ADDENDUM NO.: 3

DATE OF ADDENDUM: December 2, 2015

**ROOF REPLACEMENT AND MECHANICAL IMPROVEMENTS  
WINDHAM TECHNICAL HIGH SCHOOL  
210 BIRCH STREET  
WILLIMANTIC, CT  
BI – RT – 862**

SK-1

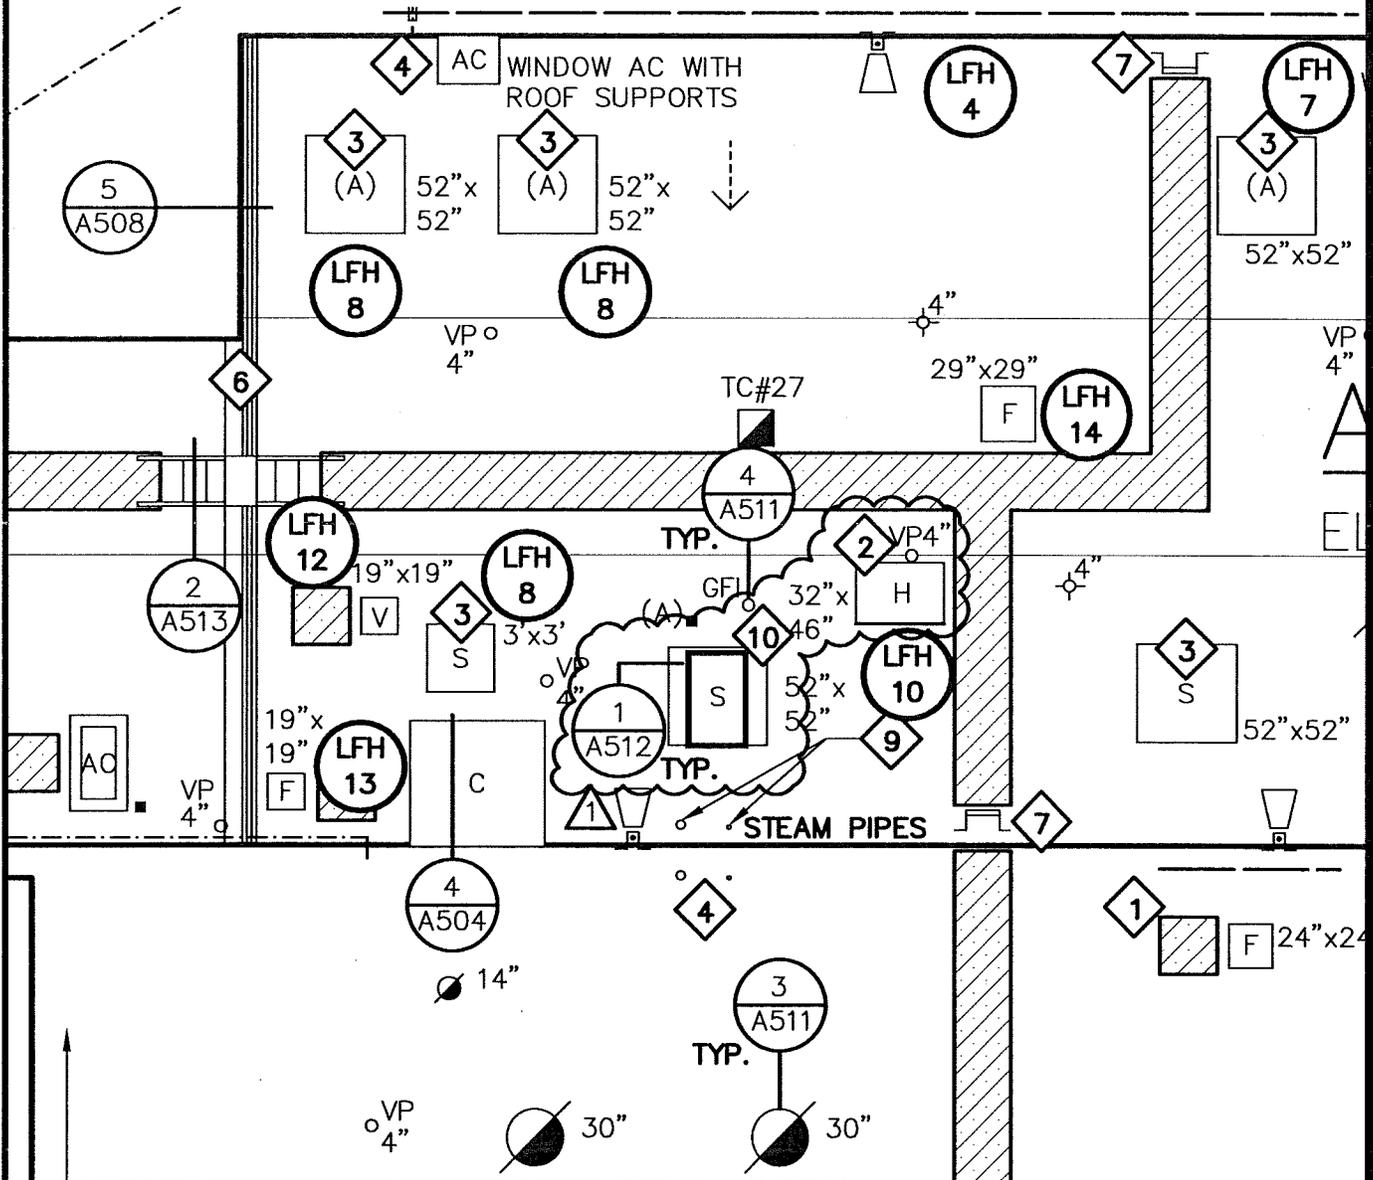
- B. On drawing A1.06, REVISE Partial Roof Area Plan – Roof Area J per SK-1.

FURNISH AND INSTALL NEW ROOF HATCH, CURB, FLASHINGS, AND ACCESSORIES. REFER TO STRUCTURAL DRAWINGS S102 AND 6/S501 FOR SUPPLEMENTAL STEEL FRAMING. INSTALL DECK INFILL AS REQUIRED. COORDINATE ROOF DECK OPENING WITH NEW ROOF HATCH. FURNISH AND INSTALL NEW INTERIOR ROOF ACCESS SHIP LADDER.

**Item 4 – Roof Area J Roof Hatch**

- A. In specification 05 50 00, ADD Article 2.08 as follows:

2.08 NEW ROOF ACCESS SHIP LADDER

- A. General: Ladder design shall be a delegated design system that is designed to provide a minimum tread load of 350 pounds. The ladder shall fit within the existing skylight space between the new roof joists at a width no less than 36" clear between the stringers and at an angle of 75 deg.

SK-2

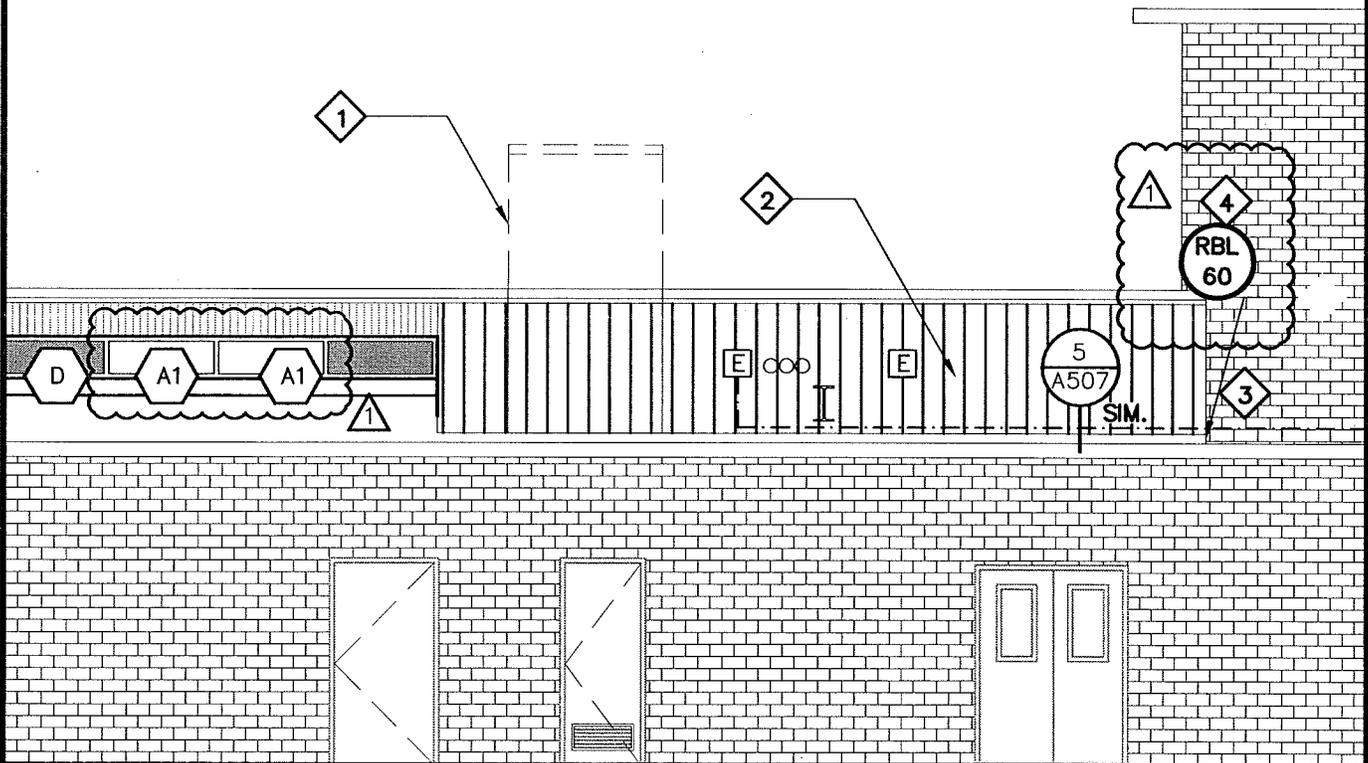
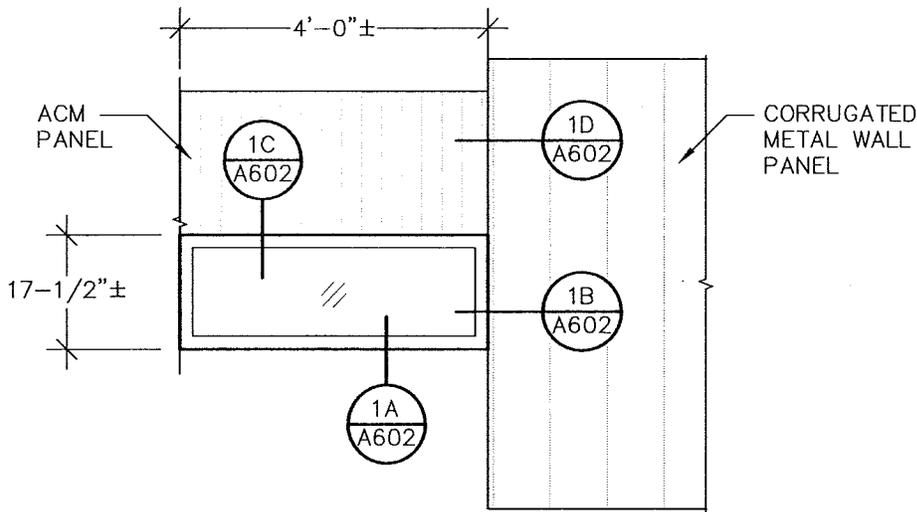
- A. Contractor shall include masonry rebuilding on the West Clerestory Elevation above Roof Area J. On drawing A204, REVISE Partial West Clerestory Elevations per SK-2.

INSTALL END DAM AT LIMITS OF THROUGHWALL FLASHING AND WHERE NEW PANEL SYSTEM TERMINATES.

REBUILD EXISTING MASONRY VENEER AT CORNER INCLUDING ON THE NORTH ELEVATION. MASONRY WORK SHALL BE COMPLETED PRIOR TO THE NEW METAL WALL PANEL INSTALLATION.

SK-3

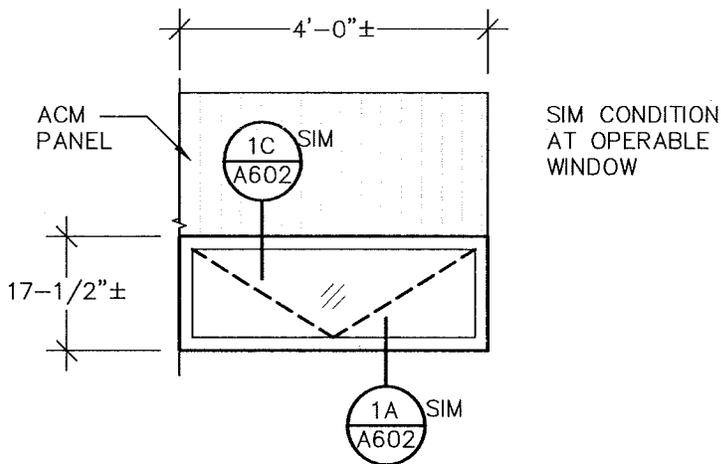
- A. In specification 08 41 00 , Article 2.02, ADD paragraph B.2 as follows:
  - B.2 Operable units shall meet or exceed designation AW-PG80-FW.
- B. In specification 08 41 00, Article 2.03, ADD paragraph A.2 as follows:
  - A.2 Operable Aluminum Window
    - a. Basis of Design: Traco 2400 Projected Flush Project In
- C. On drawing A204, REVISE Partial West Clerestory Elevations per SK-2.
- D. On drawing A602, REVISE Window Schedules per SK-3.

# SK-4

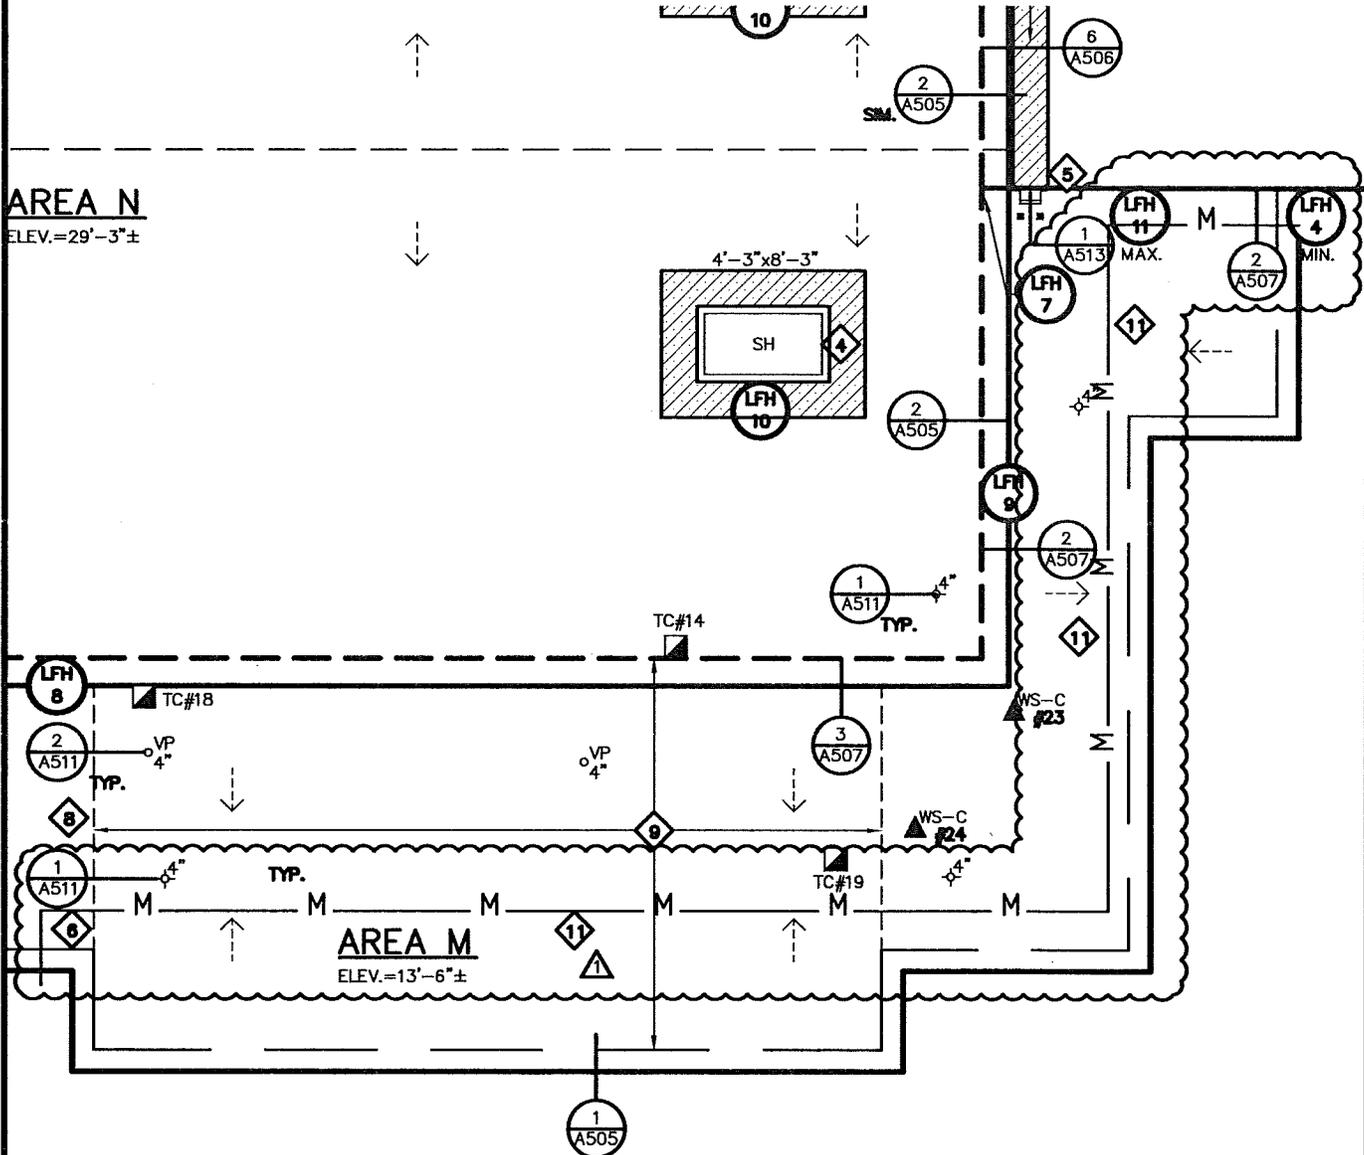
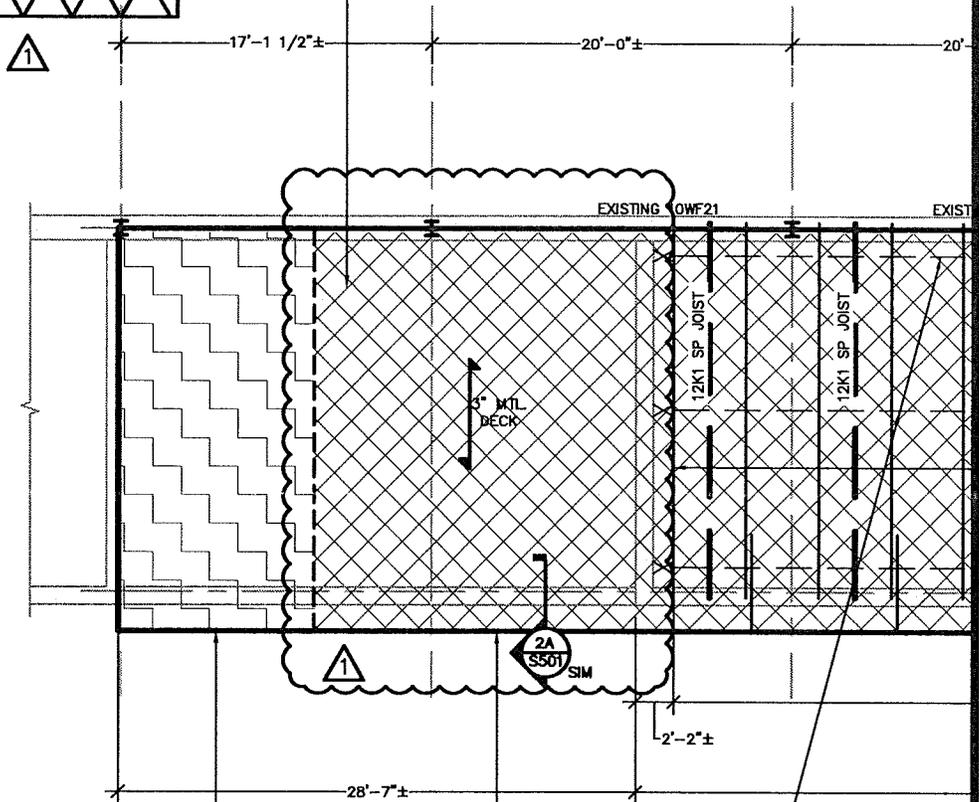
- A. On drawing A1.01, REVISE Partial Roof Area Plan – Roof Areas A, B, N, and M per SK-4.
- B. On drawing S103, REVISE Partial Framing Plan – Area M per SK-5.

NEW GAS PIPING AND SUPPORT STANDS INSTALLED ON ROOF AREA M BY OTHERS. CONTRACTOR TO ADJUST HEIGHT AND PROTECT PIPING AS REQUIRED FOR NEW ROOFING AND DECKING. CONTRACTOR TO PROVIDE NEW PADS UNDER PIPE STANDS PER 4/A513 AND M401.
